Ref:	NR/L2/ELP/27009/MOD C28
Issue:	1
Date:	03/12/2011
Compliance date:	03/03/2012
Page	1 of 6

OVERHEAD LINE CAMPAIGN CHANGES – DATA SHEET

MODIFICATION OF CROSS - CONTACT BRIDGE ASSEMBLIES

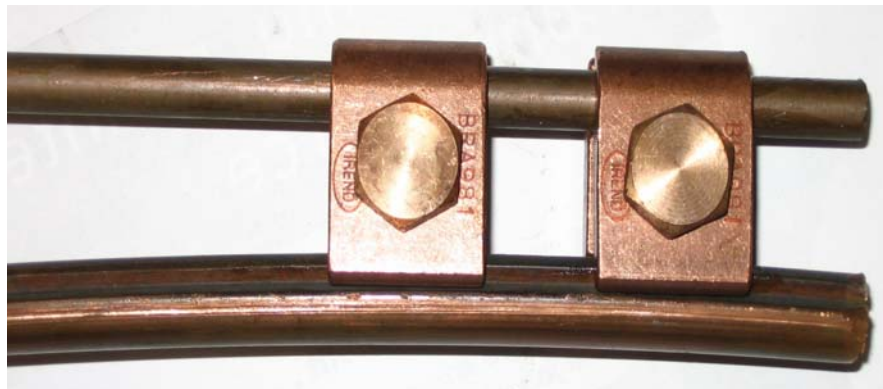
COMPONENT Cross-contact bridge assemblies, as follows:

1. With a $\frac{7}{16}$ " copper rod bridge;
2. With 2-off parallel grove clamps clamped around a contact wire bridge;
3. With 2-off 125/003/001 type parallel grove clamps, clamped into the groove of a contact wire bridge.

PROBLEM High pantograph forces and contact wire uplift causes the cross-contact fastenings to work loose. This leads to the cross contact bar falling foul of pantographs. In addition $\frac{7}{16}$ " copper rod has been prone to fracture.
